Subject: **FCC Class II Permission Change Request for FCC ID: N82-KOHLER053**

This is to request a Class II Permission Change Request for FCC ID: N82-KOHLER053, originally granted on 09/26/2023.

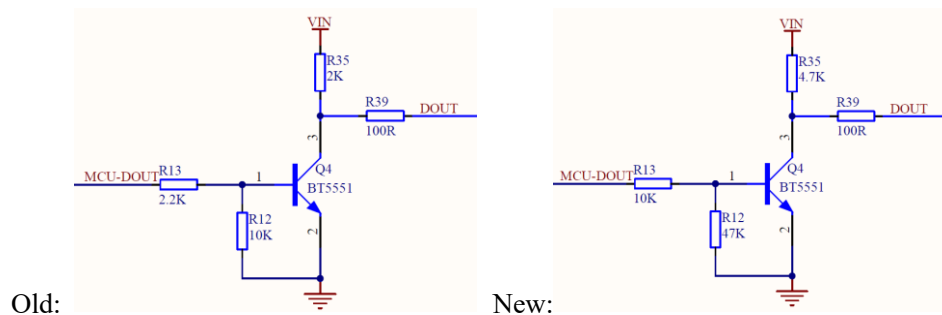
The Major change filed under this application is as below and add a model 1521839

No.	Site	Component	Old	New	Comment
1	U5	LDO	RUN-IC RS3005-3.3	CHANGJING CJ6376A33MR	5V to 3.3V
2	R13	Resistor	2.2K	10K	Driving resistor of transistor base
3	R12	Resistor	10K	47K	Pull-down resistor of transistor base
4	R35	Resistor	2K	4.7K	Pull-up resistor of transistor collector
